RESPONSE TO COMMENTS

IDCP RESPONSE TO COMMENTS

CHAPTER 3 OPEN SPACE

FIGURE R10.1.1A

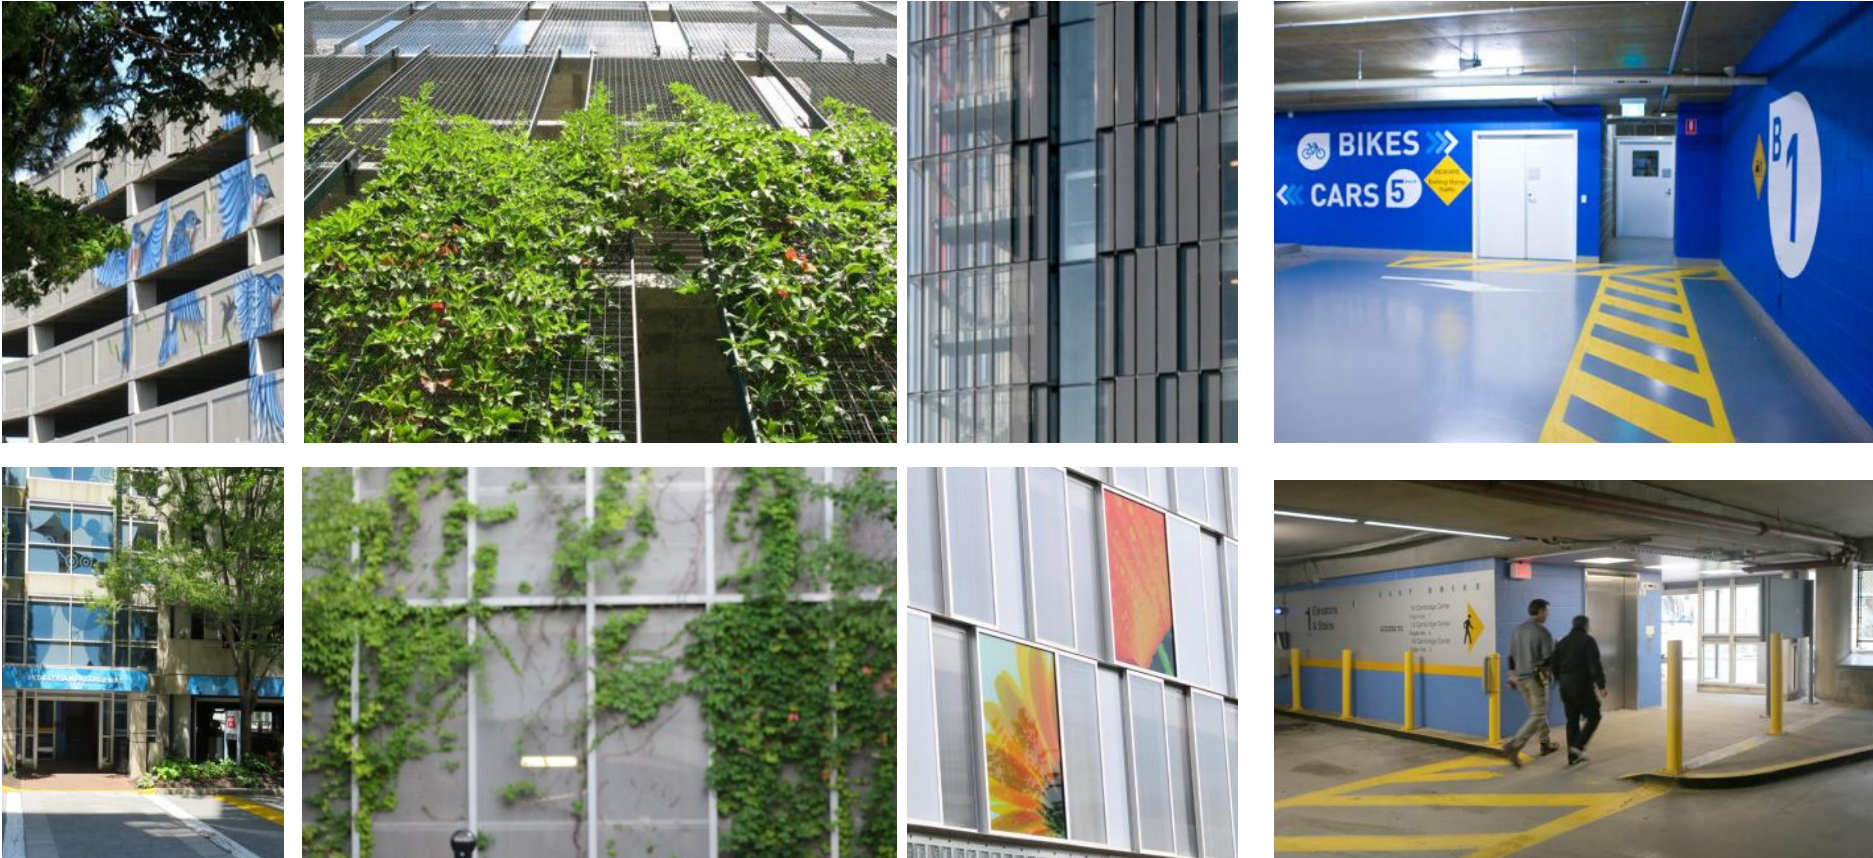
R10.1.1 DESIGN GUIDELINES: CDD staff has requested the addition of more information about the architectural and urban design character of the building façade treatments.

Within the MXD district, recent developments have proposed to mask existing garage structures with new building proposals. For exposed parking garage surfaces, murals and screening devices or the continuation of building facade fenestration can be introduced when appropriate to mask or enliven these existing structures without impacting necessary open area for ventilation of the garage functions.
